G434-139
cont'd

ENVIRONMENTAL ANALYSIS

FIGURE 4: Detail from map in Dailey et al; arrow shows prevailing West-to-East surface current at project site. (Contrast with map in the DEIS/R.)

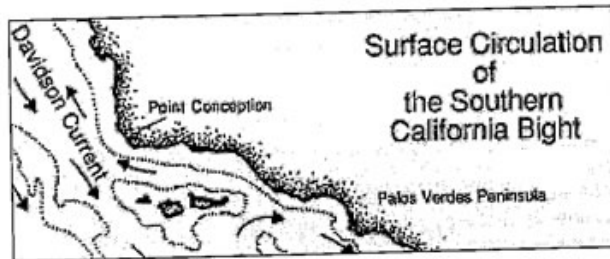
The Scoping Draft misstated the direction of the prevailing ocean currents,²¹⁸ and the DEIS/R continues to do so. They contradict the map given in Dailey et al,²¹⁹ by omitting some vectors and emphasizing others to suggest that current flow in the site location is offshore. In fact, based on maps, and my own experience sailing in that location, current flow is predominantly from the NW (Davidson Current), with a West-to-East current in the project area. (See my FIGURE 4.)

The figures presented in the October 2004 Draft EIS/EIR and by the commenter both represent states of circulation that occur within the Southern California Bight. However, as discussed in Section 4.1.8.1, the actual circulation pattern is much more complex than either representation. To decrease any potential confusion, the circulation patterns have been deleted from Figure 4.1-1. The Final EIS/EIR includes up-to-date available data on currents.
